September 13, 2021

Pearl High School Indoor Training Facility
Pearl, Mississippi

ADDENDUM NO. 03

UTILITY PLAN
SCALE: 1"=20'-0"

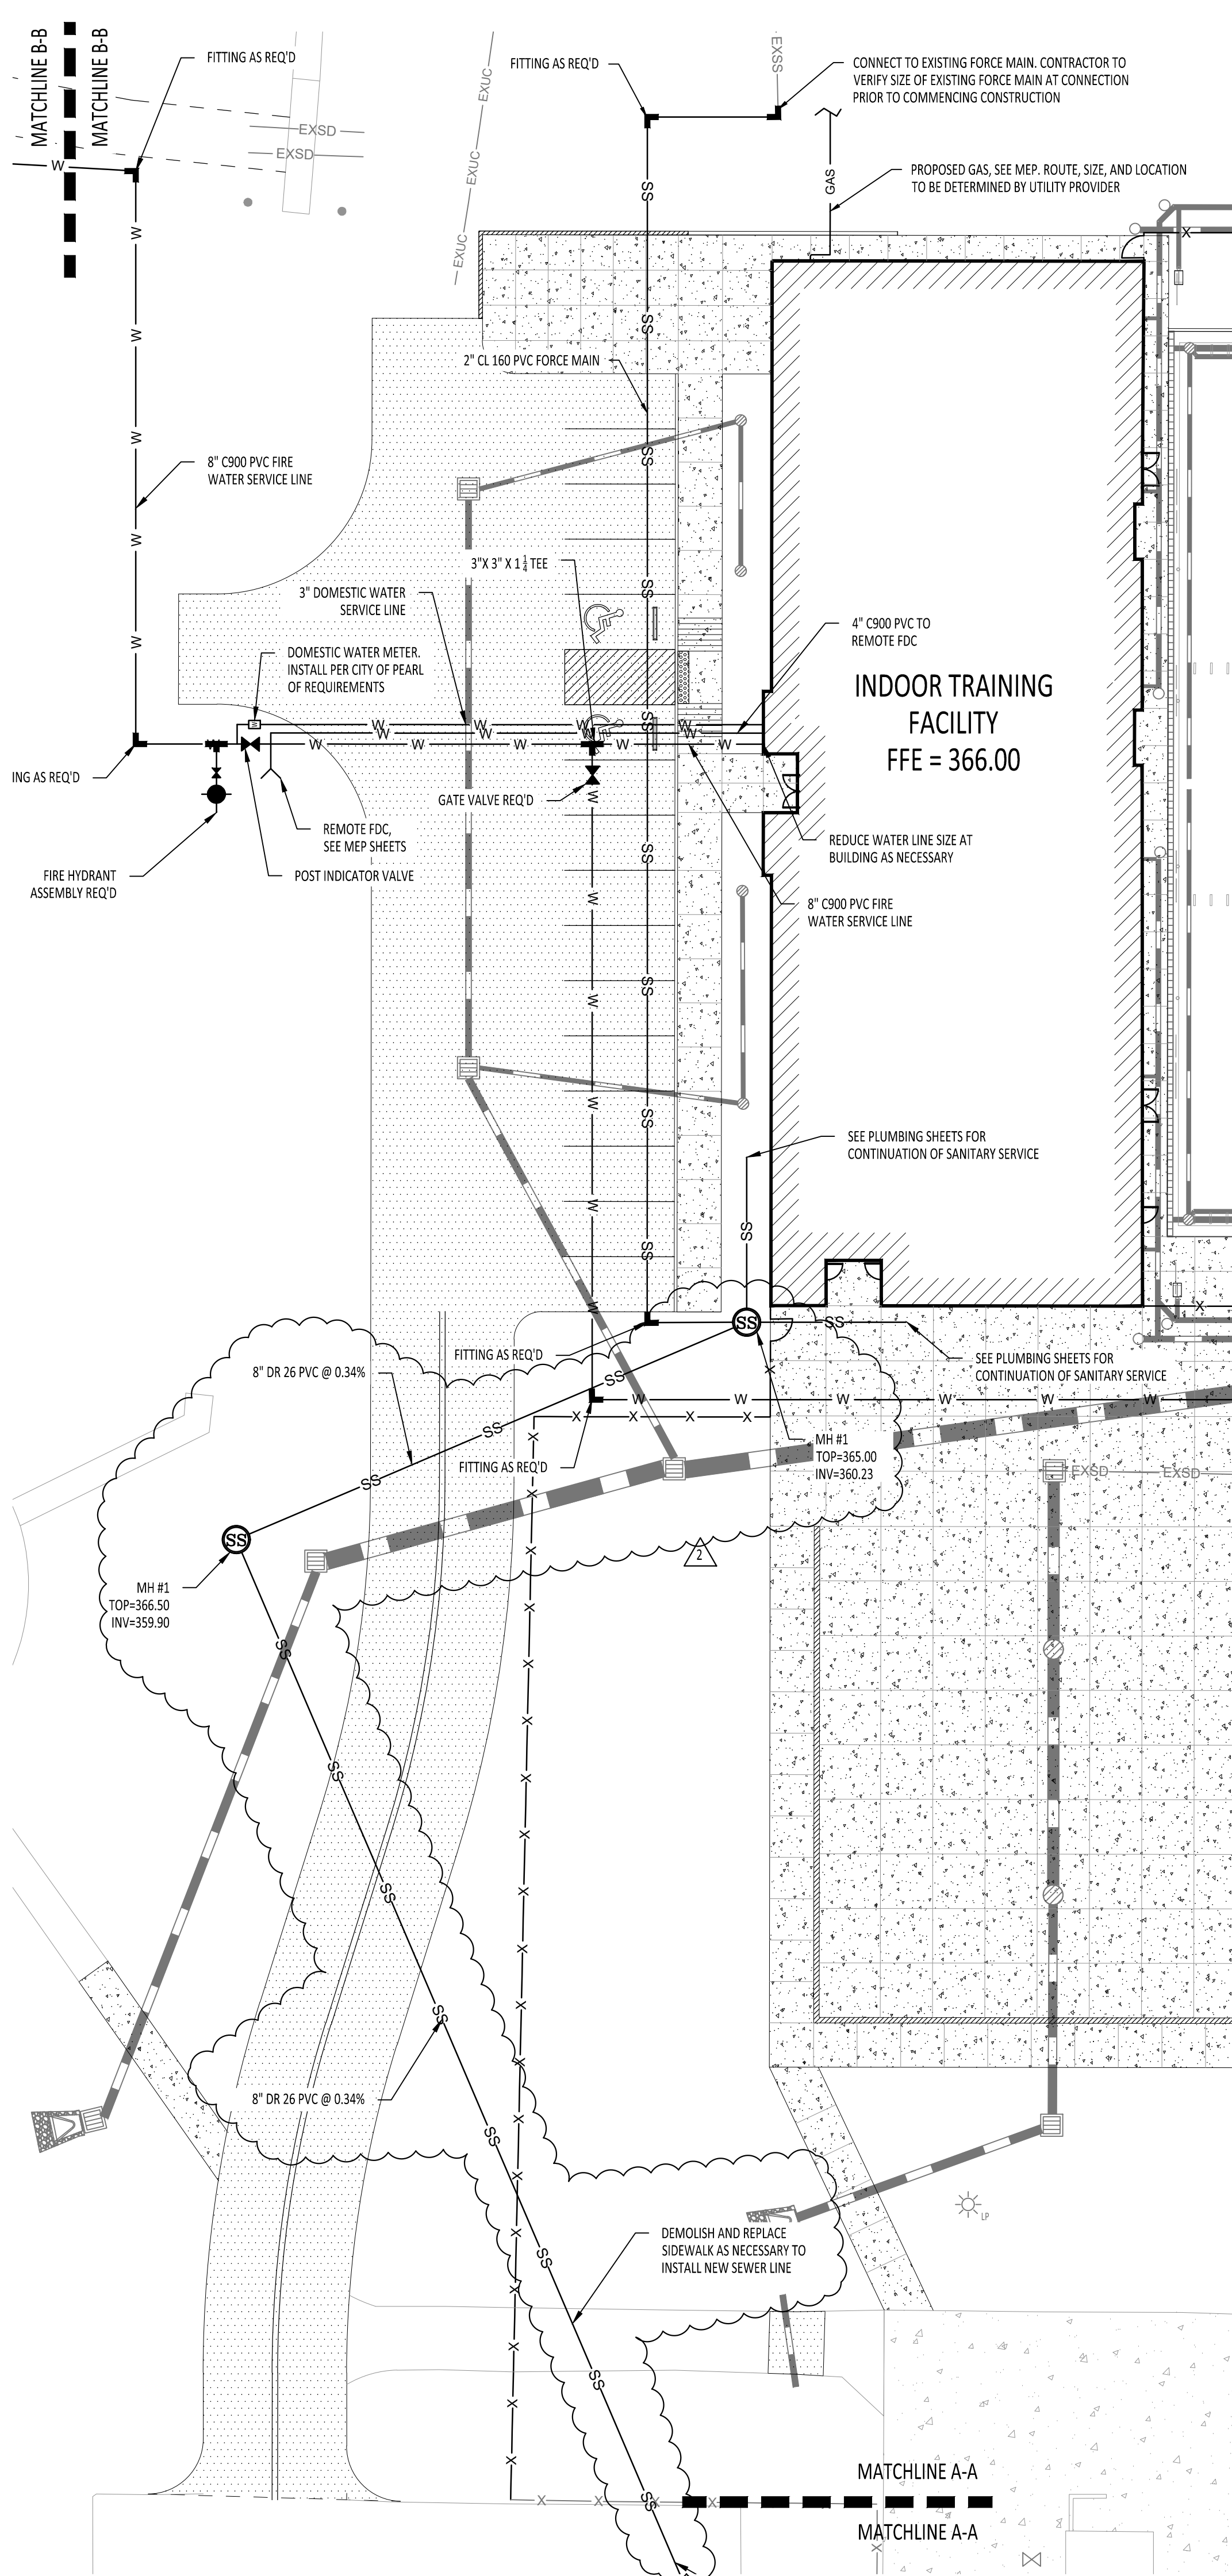
C141 UTILITY PLAN

Revise per the enclosed sheets

C205
CIVIL
DETAILS

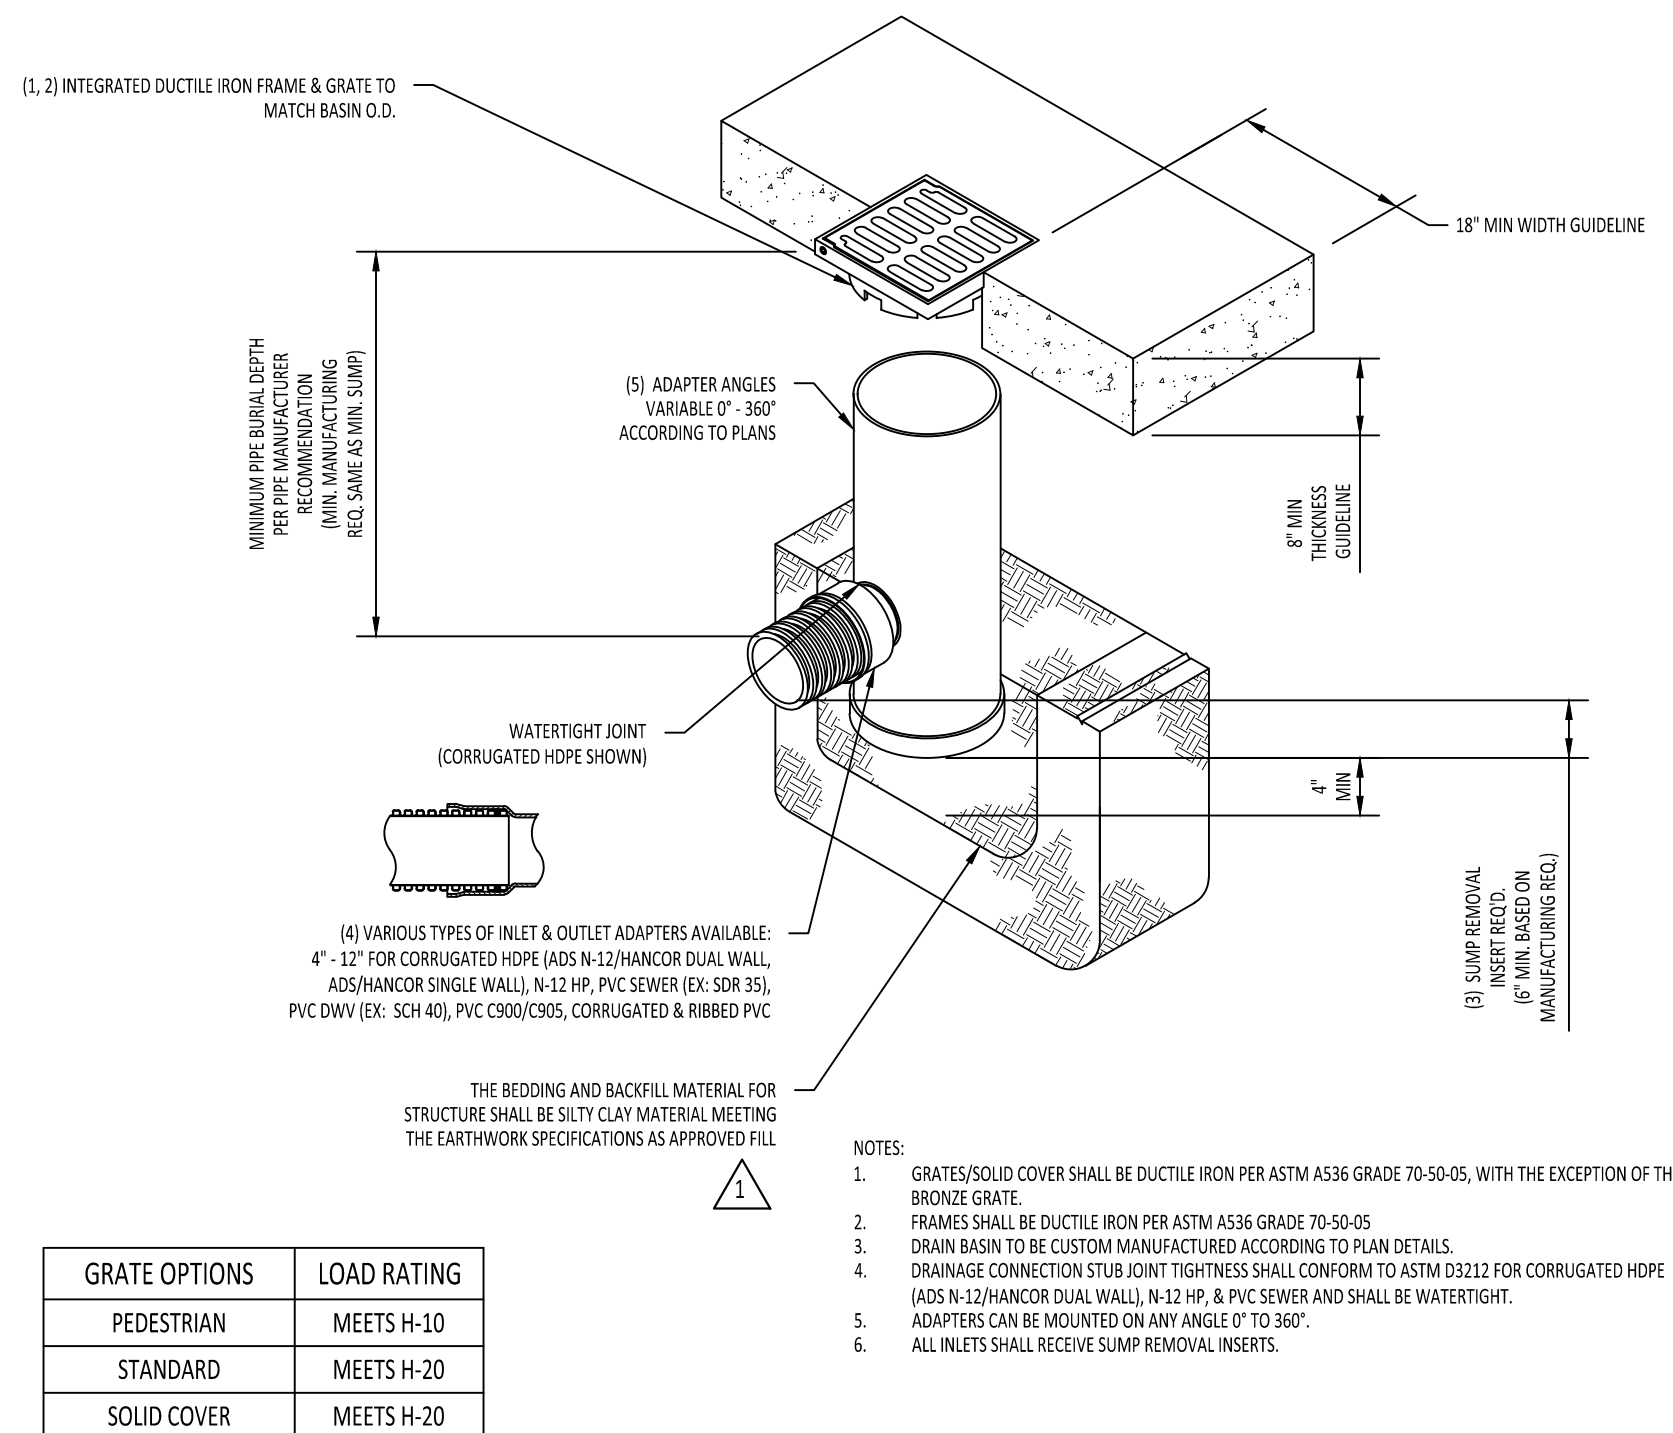
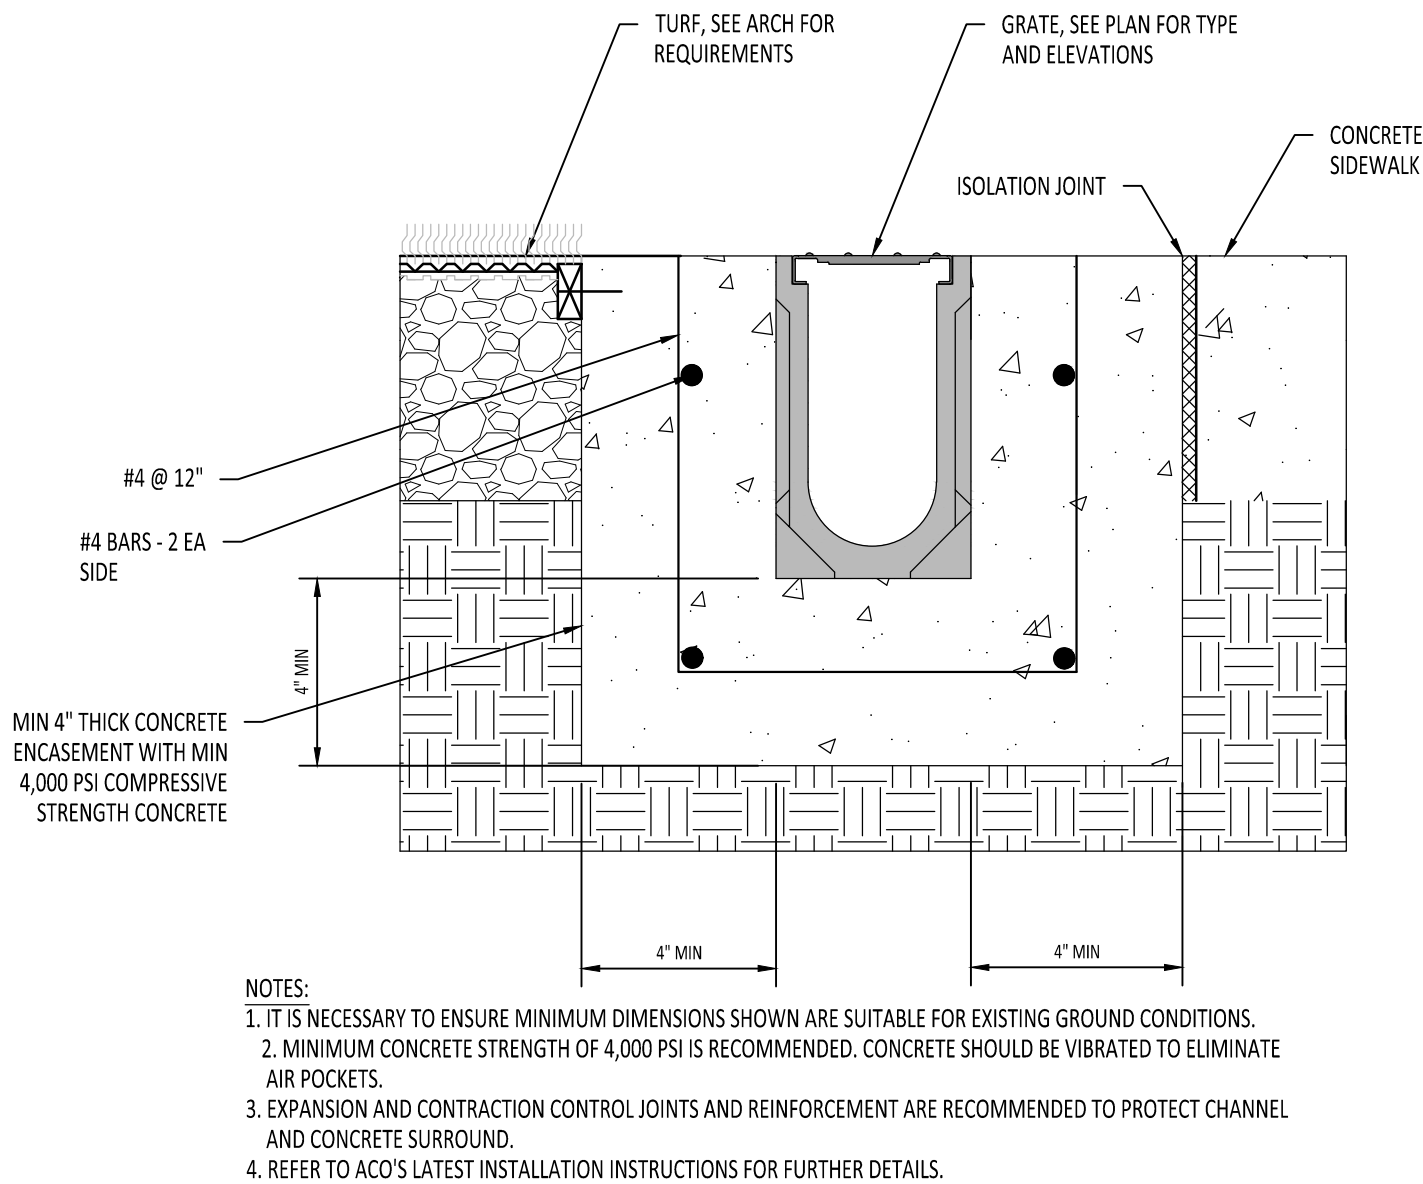
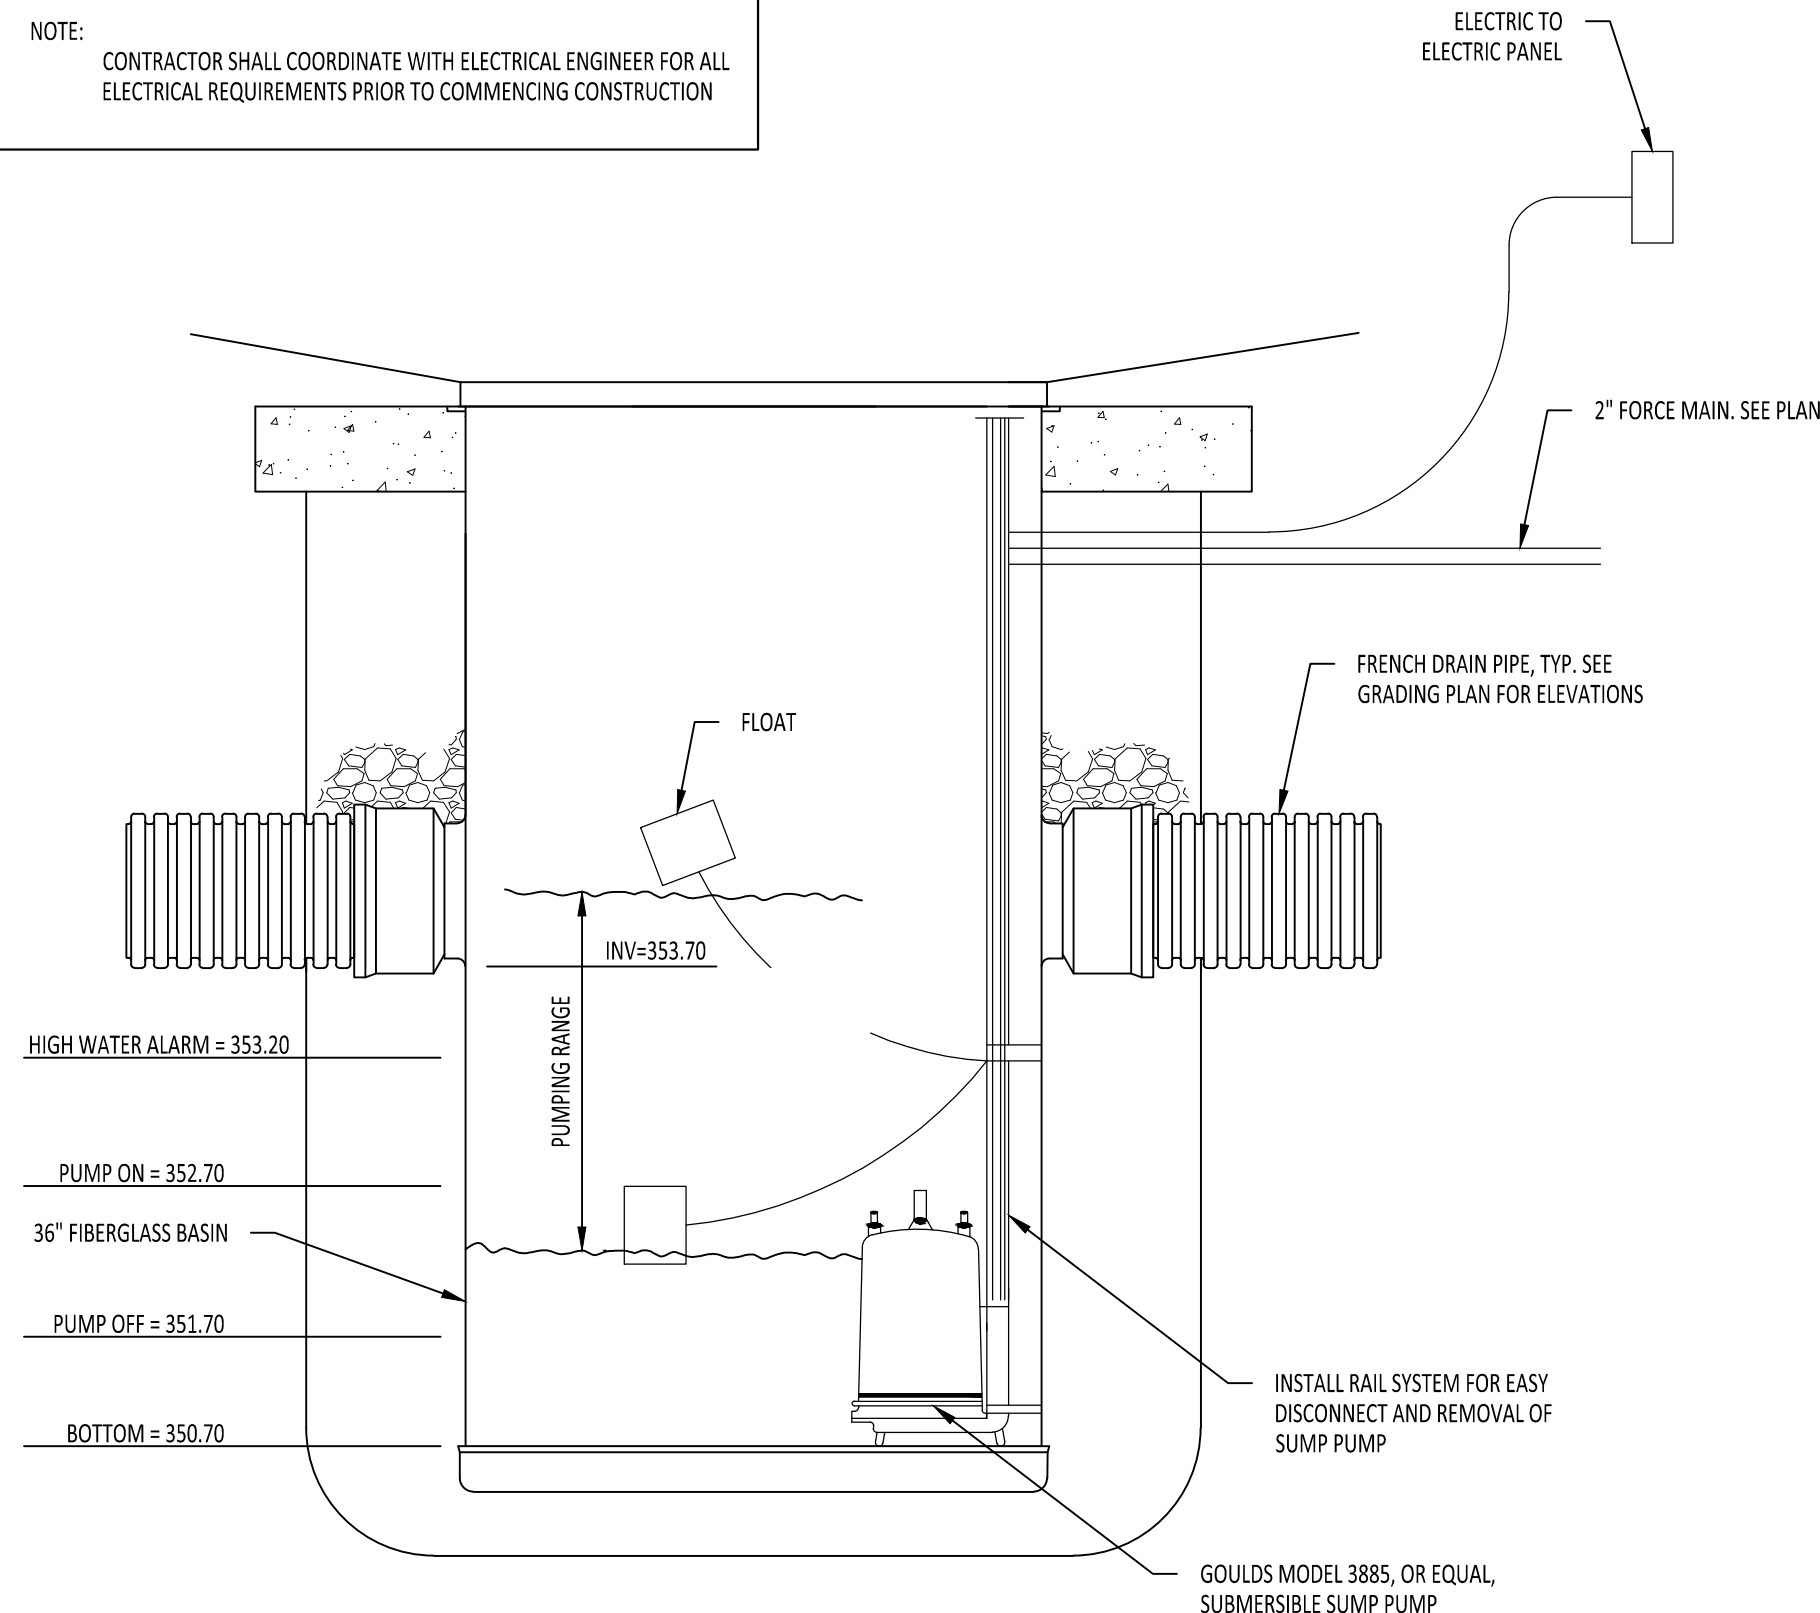
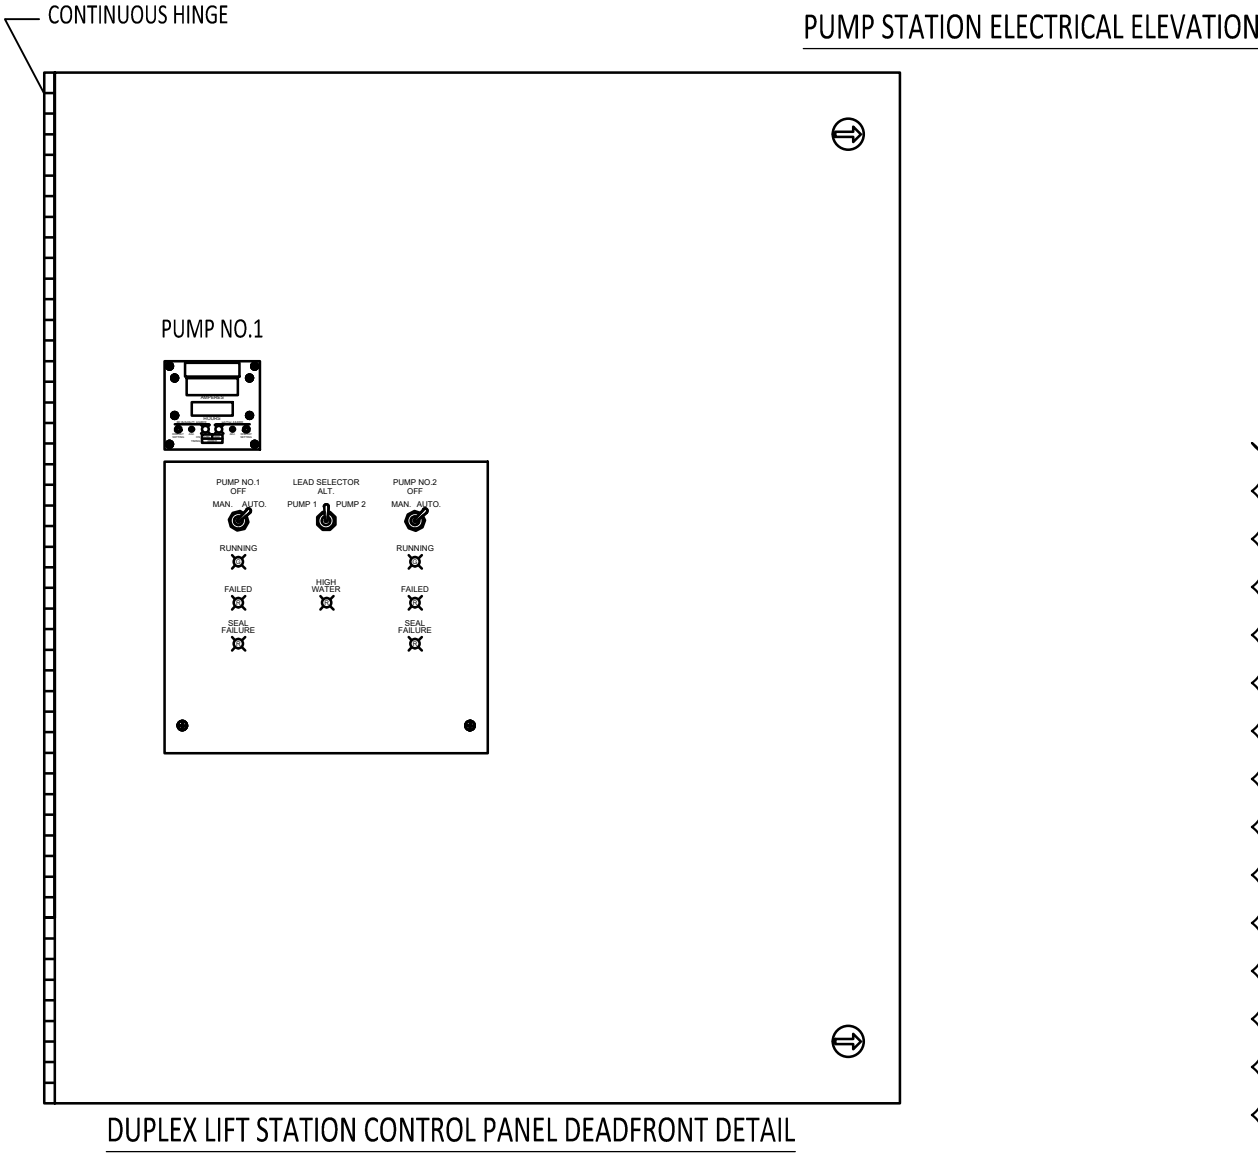
C205 CIVIL DETAILS
